DART SERVICE INSTRUCTION

TO AMEND IIN-D412-704 REV. C OR EARLIER

AND ICA-D412-704 REV. 4 OR EARLIER

REF CANADIAN STC SH93-34

Figure 5 - Detail L or Figure 25-4 - Detail L

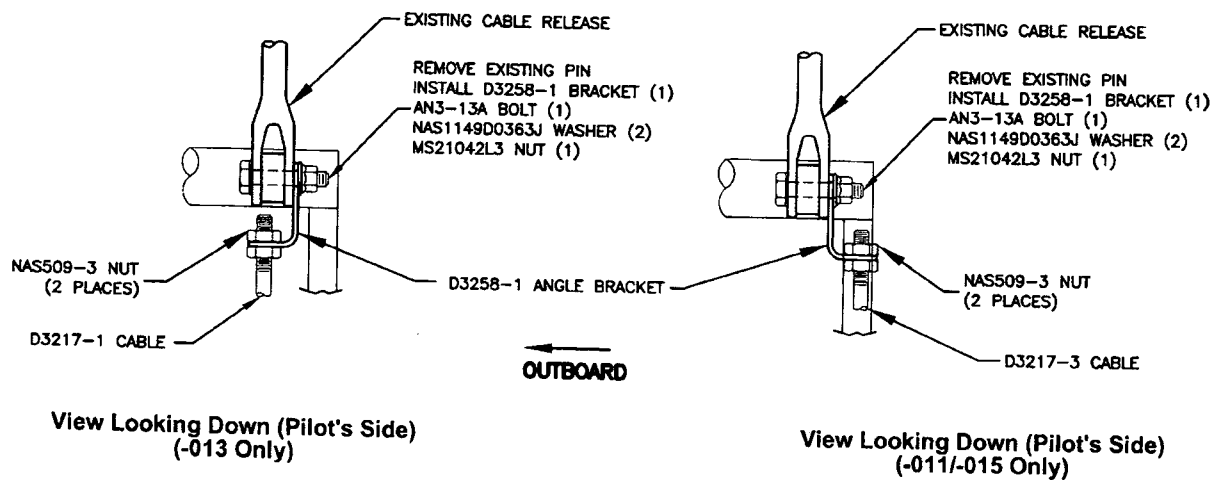
The purpose of this Dart Service Instruction is to correct part number error in Installations Instruction IIN-D412-704 Rev. C or earlier and Instructions for Continued Airworthiness ICA-D412-704 Rev. 4 or earlier. The AN3-13A bolt should be replaced with an AN3-10A bolt in Figure 5 - Detail L in IIN-D412-704 and Figure 25-4 Detail L in ICA-D412-704. See sheet 2.

FIGURES CORRECTION

Revise Detail L Figure 5 of IIN-D412-704 and Detail L Figure 25-4 of ICA-D412-704 as follows:

NOW

WAS
